**Application for Permission Under Section 16 of the Town Planning Ordinance (Cap. 131) for Proposed Temporary Educational Institution (Teaching Farm) and Associated Excavation of Land for a Period of Three Years at Various Lots in D.D. 16, Wo Tong Pui, Tai Po, New Territories
(Planning Application No. A/NE-LT/794)**

Submission of Further Information

Responses-to-Comments table

Figure 3.3 Schematic diagram of Deodorization System

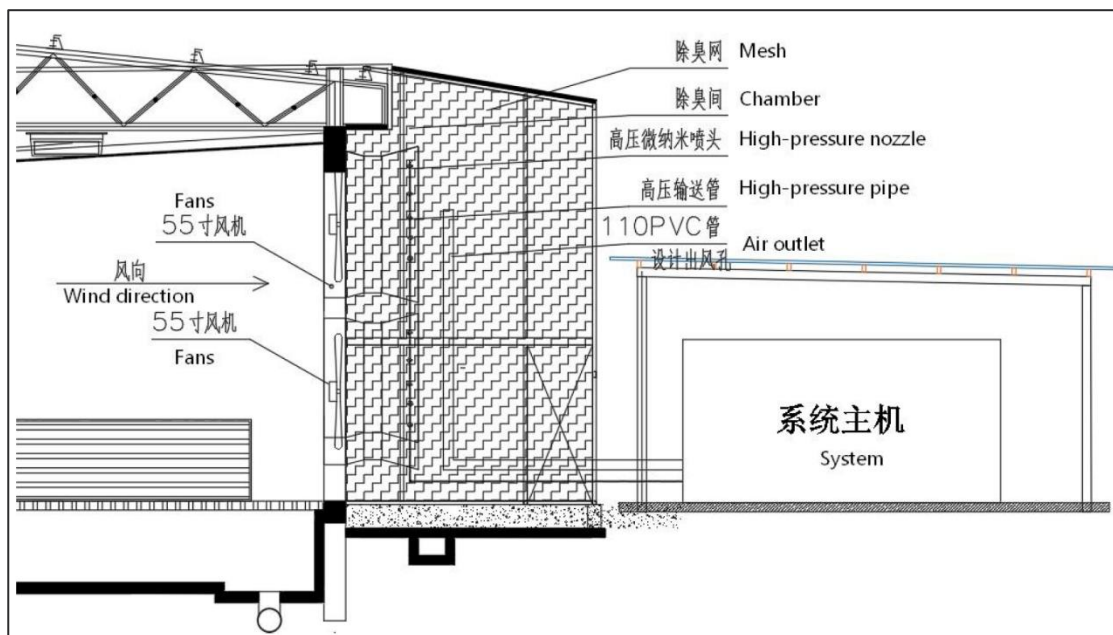
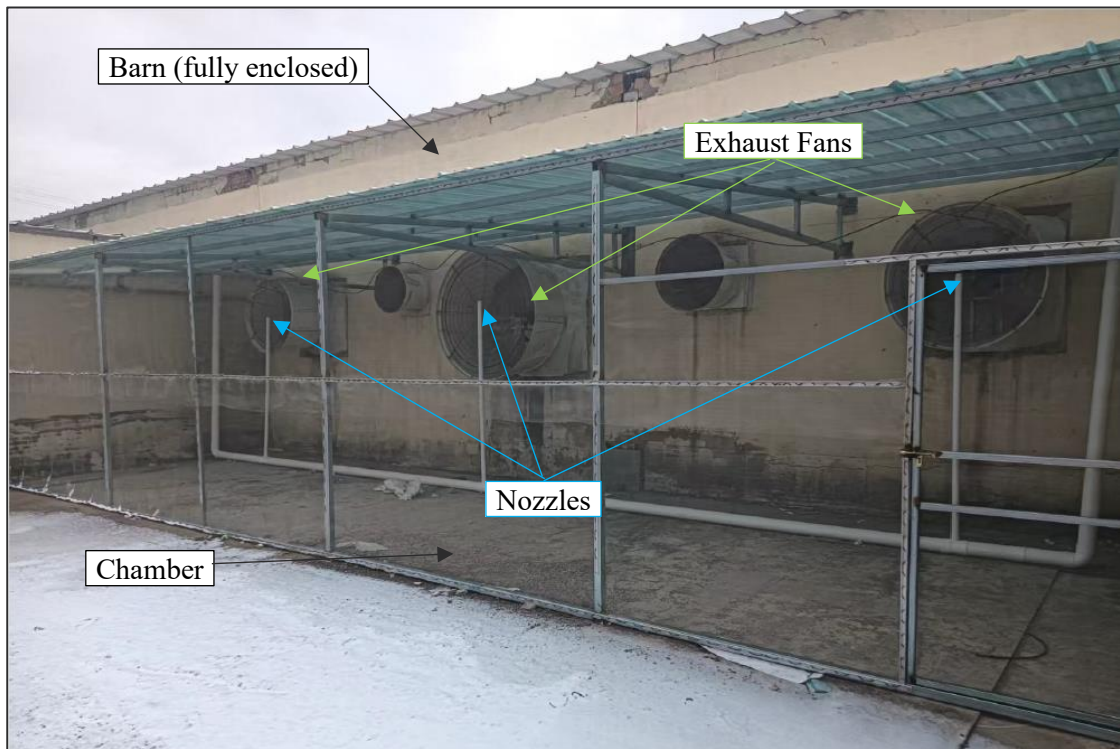
No.	Comments	Responses
	10. Section 3.5.4: Please explain why the odour impact from an uncovered overground sewage holding tank would be negligible. 11. Section 3.5.11: Please clarify whether the micro-nano deodourisation system is represented by Block 14 in Figure 2.2. 12. Please supplement the responses to our previous comment and update the report accordingly: Please check with regional office of EPD to see if there are any odour complaints against the existing Farm 1.0 in recent years. Please clarify whether odour patrol has been conducted to confirm the odour from the existing facilities.	composite moving-bed biofilm reactor are all housed within the unit and fully enclosed by the watertight cover of the pre-treatment facility. As such, no adverse odour impact is anticipated from the operation of the animal wastewater pre-treatment system. It should be "underground sewage holding tank" and refers to the existing arrangement at Farm 1.0. Under the proposed Farm 2.0 development, domestic sewage will be discharged directly to the public sewerage system and, therefore, any associated odour emission is expected to be negligible. The micro-nano deodourisation system is a new facility to be installed in Block 15. During the operation of Farm 1.0, odour mitigation measures included ventilation systems fitted with activated carbon filters and the application of biochar produced at EcoPark in Tuen Mun. However, disruptions to the biochar supply in 2024 and 2025 coincided with the receipt of odour complaints. After the biochar supply resumed, CityUHK Farm increased the application rate of biochar to the floor areas, particularly during wet weather. Good housekeeping practices were also implemented, including operator collection of manure and storage in underground manure scrape pits with stainless steel covers. These measures were effective in preventing odour, and no further complaints were received thereafter. The farm operator kept continuing to review the effectiveness of the existing odour control measures to minimize potential odour impacts as far as practicable. There will be improvement in the odour emissions from the facilities after this Project, such as new deodorization system for the new barn, dry-wet system and public sewer collection will be adopted to reduce

- 3.5.12 A micro-nano deodorization system, as illustrated in the accompanying schematic diagram (see Figures 3.3 and 3.4), is proposed to the third barn under Farm 2.0 (Block 15 in Figure 2.2). The entire system is configured on the exhaust side of the exhaust fans,

- 3.5.14 The nano-molecular water and ozone are mixed and sprayed through nozzles at the fan exhaust outlets (as shown in **Figure 3.3**), allowing direct contact with the odorous air stream prior to discharge. This treatment process facilitates odour reduction before release to the surrounding environment. Based on operational experience from similar agricultural facilities, barn odours are mainly associated with ammonia, which is highly soluble in water. Measurements obtained from comparable installations indicate that the system can achieve an ammonia removal efficiency in the range of approximately 75% to 90%.
